<b>JRPP No:</b>	2011HCC018
<b>Application No:</b>	736/2010
<b>Description of Land:</b>	Lots 7, 8, 9 and 10 in DP 17377 No's 31 – 33 Ocean Parade and 11 – 13 Bayview Avenue, The Entrance
<b>Proposed Development:</b>	Residential Flat Development
<b>Site Area:</b>	3,304.1m <sup>2</sup>
<b>Zoning:</b>	2(d) High Density Residential
<b>Existing Use:</b>	Single storey weatherboard and brick dwelling on No 31-33 Ocean Pde, a single storey development at No 11 Bayview Pde containing 5 units and a double storey residential flat building containing 6 units at No 13 Bayview Avenue
<b>Estimated Value:</b>	\$15,000,000
<b>Applicant:</b>	De Angelis Taylor Associates
<b>Owner:</b>	Kiellie Pty Ltd, Kymill Pty Ltd and The Three G's Pty Ltd
<b>Author:</b>	Mark Greer

## Assessment Report and Recommendation

**Figure 1 - Setback encroachment levels 5 and 6 in tower "B" adjacent to western boundary**

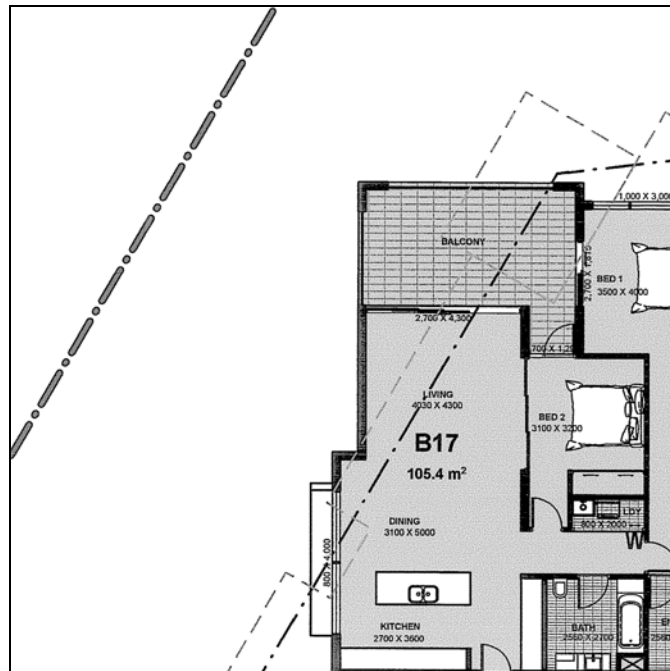
Levels 5 and 6 in towers A and B encroach into the nominal side setbacks required under Chapter 64 development guidelines. The required standard is 9 metres from the boundary to the face of the building (including a balcony). The encroachment includes open balcony space and part of the floor space of the units. For the most part the intrusions are merely part of the above mentioned components – i.e., part of the balcony or part of the unit floor area.

The portion of tower "B" that encroaches adjacent to the western and southern boundaries (see figures 1 and 2) involves mainly an open level balcony and is not considered to adversely impact on amenity by way of restricting solar access or increased noise problems.

**Figure 3 - Setback encroachment levels 5 and 6 in tower "A" adjacent to northern boundary**

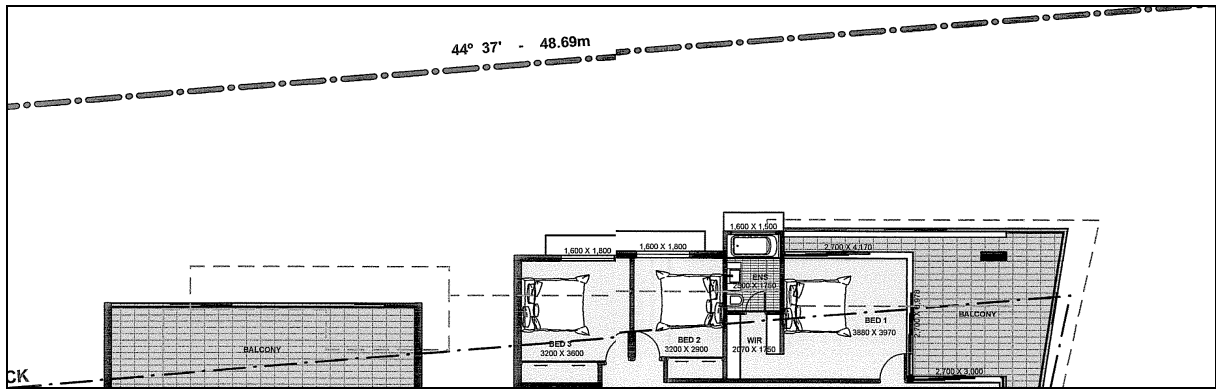
The portion of tower "A" that encroaches adjacent to the northern boundary (see figure 3) involves an open level balconies and bedrooms. This part of tower "A" is on the southern side of the neighbouring residence and is not considered to adversely impact amenity by way of restricting solar access or increase noise problems.

**Figure 7**

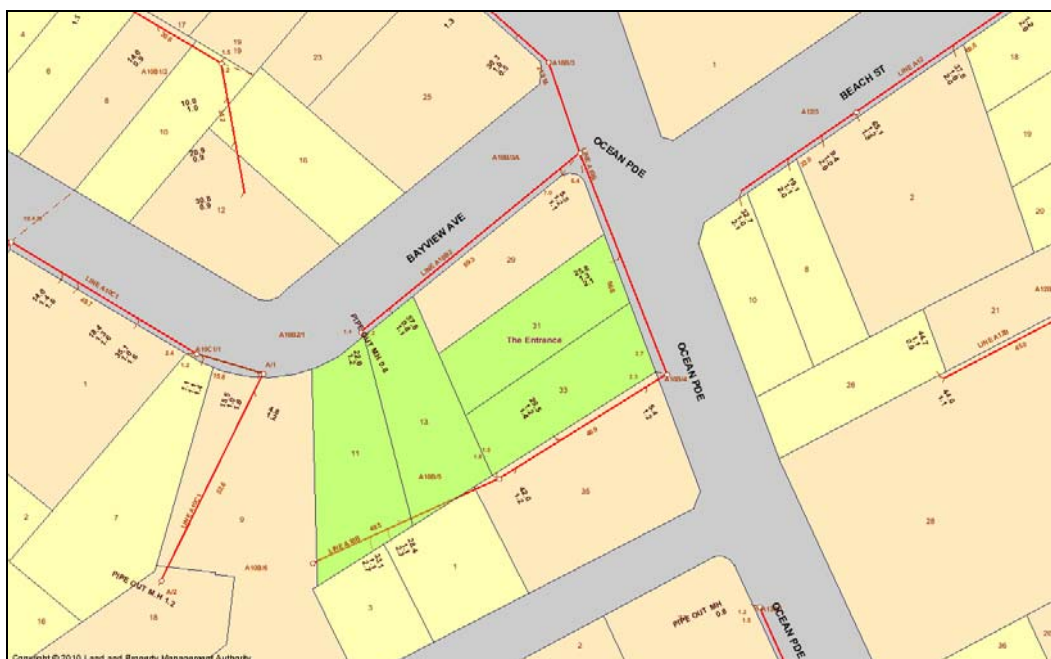
The site is currently serviced for sewer via existing lines (as are detailed on Figure 7). There are four sewer junctions within the development site and the developer may connect to either junctions. The unused junction is to be plugged in accordance with Council's Chapter 67 – 'Engineering Requirements for Development'.

The developer is fully responsible for the protection of the sewer line during the construction of the basement car park. Any required relocation of the sewer line will be the sole responsibility of the developer. Likewise, the developer will be responsible for maintaining services to other properties that are connected to this main.
